Address:	3706 Bradley Lane, Chevy Chase	Meeting Date:	11/16/2022
Resource:	Contributing Resource Chevy Chase Village Historic District	Report Date:	11/09/2022
Applicant:	Kyle Rabe (Lila Fendrick, Architect)	Public Notice:	11/02/2022
Review:	HAWP	Tax Credit:	n/a
Permit No.:	1008218	Staff:	Rebeccah Ballo
Proposal:	New fences and hardscape alterations.

MONTGOMERY COUNTY HISTORIC PRESERVATION COMMISSION STAFF REPORT

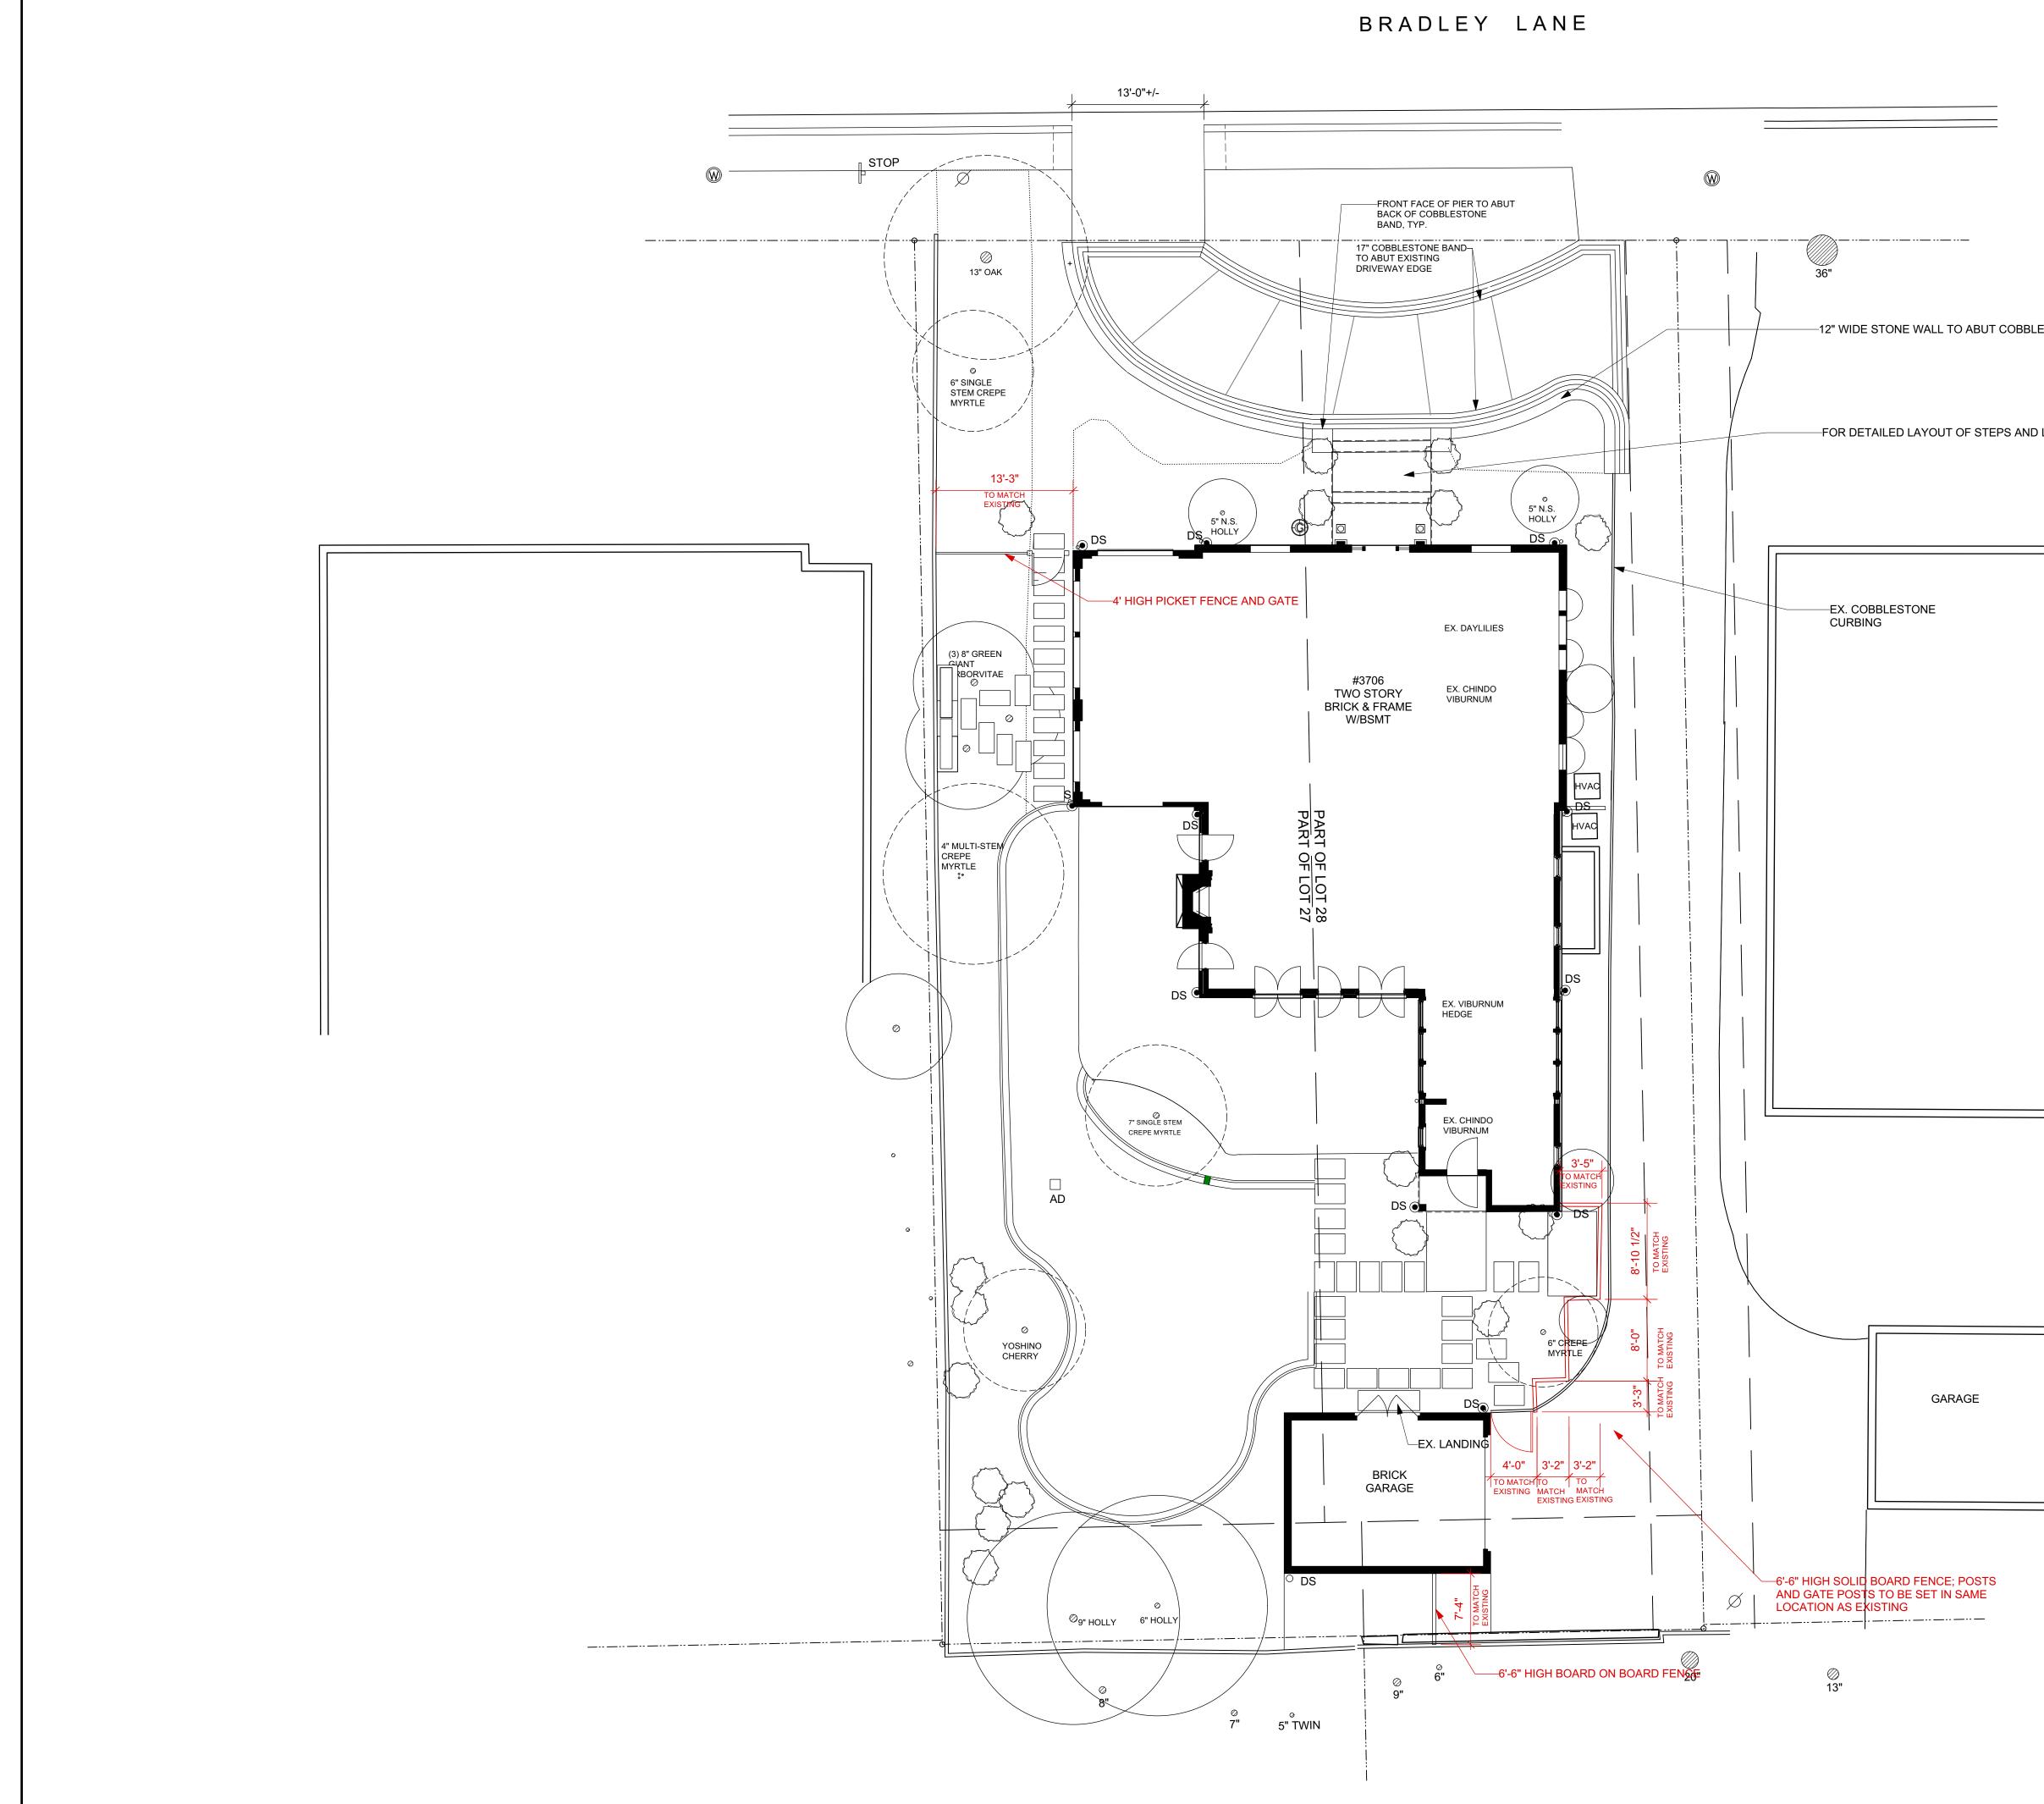
The fence alterations are replacing existing fencing in the same heights, runs, and materials as what currently exists. Typically, this would not require a HAWP; however, upon reviewing the 2006 HAWP approval, the HPC placed a condition on the proposed (now existing) fences that they be no taller than 6' and not the 6'6" as proposed. It appears that the existing fences were constructed at the incorrect height of

6' 6". Therefore, staff recommends a condition of approval in line with the previous application—namely, that the privacy fences not exceed 6' in height. This is an alteration from the existing condition and requires the HAWP for the change. This is an appropriate height under the "Moderate Scrutiny" guideline required for the visible privacy fences.

1) The board-on-board privacy fences shall be 6' tall in accordance with the condition of approval from the previous HAWP 35/15-06FF approved at the November 15, 2006 HPC hearing.
